## **RESPONSE TO 4<sup>TH</sup> ROUND COMMENTS**

<b>Third Submission Review:</b>	1900 S Chambers Community Lot 1 - Site Plan Amendment
<b>Application Number:</b>	DA-2105-01
<b>Case Numbers:</b>	2018-6020-03

# 1900 SOUTH CHAMBERS COMMUNITY LOT 1 SITE PLAN

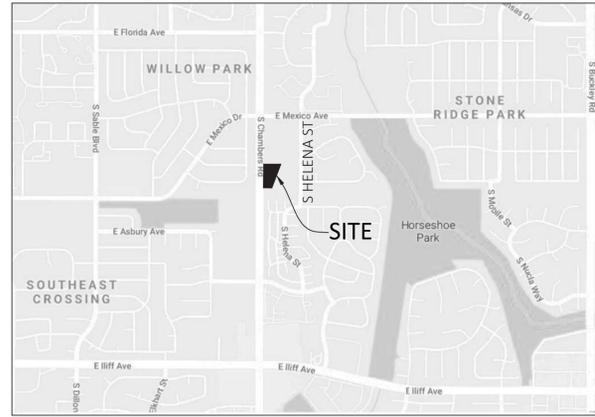
The site plan will not be approved by public works until the preliminary drainage letter/report is approved. **NOTED.**

SP-1 (2 OF 13)

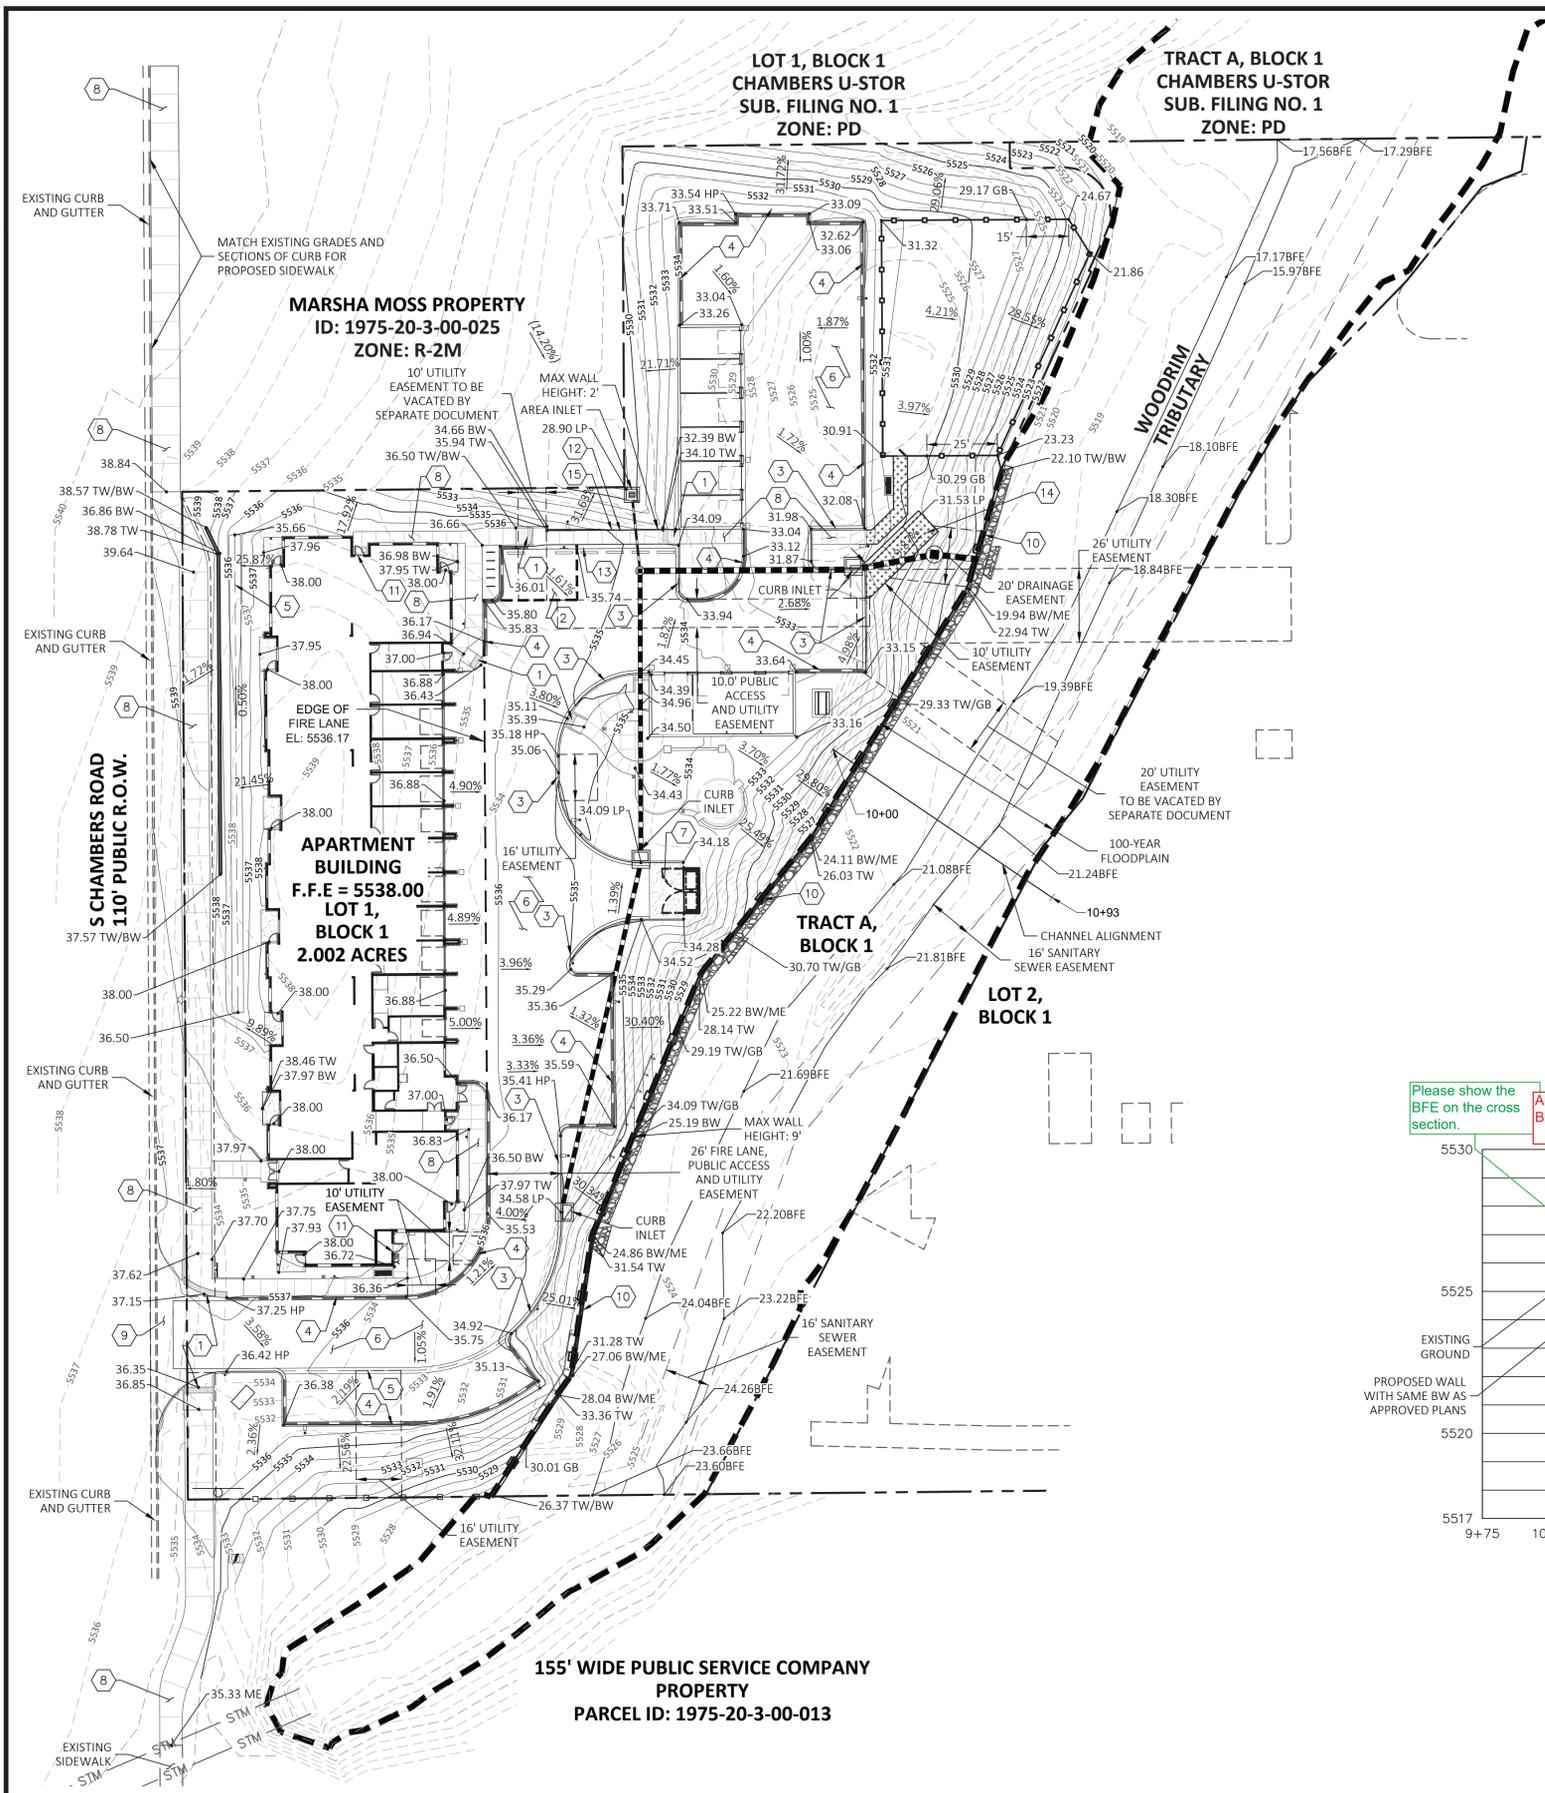
delete Block designation in the Tract  
**REMOVED "BLOCK 1"**

continue these easement releases - contact Andy Niquette at [releaseeasement@auroragov.org](mailto:releaseeasement@auroragov.org) to start the process (if these are already started with Andy, then ignore the reminder)

delete Block designation in the Tract  
**REMOVED "BLOCK 1"**

**NOTED. WORKING WITH ANDY NIQUETTE.**

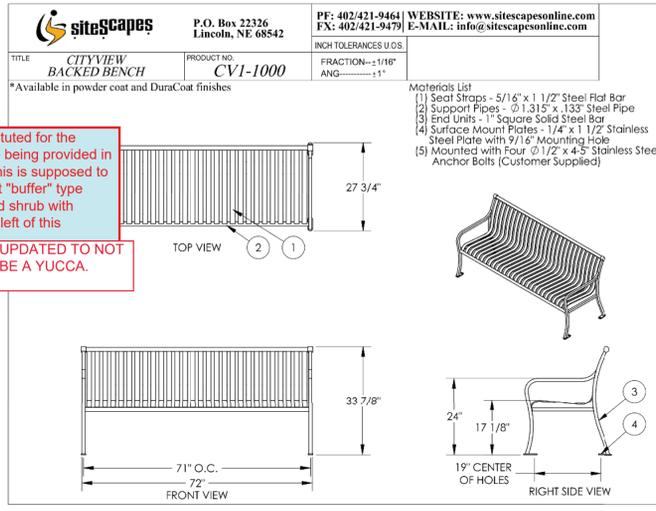
The Soapweed Yucca was substituted for the grasses and perennials that were being provided in the previous submittal however this is supposed to be a buffer and the Yucca are not "buffer" type plant material. See a more solid shrub with branching. See image to the left of this comment.

UPDATED TO NOT BE A YUCCA.
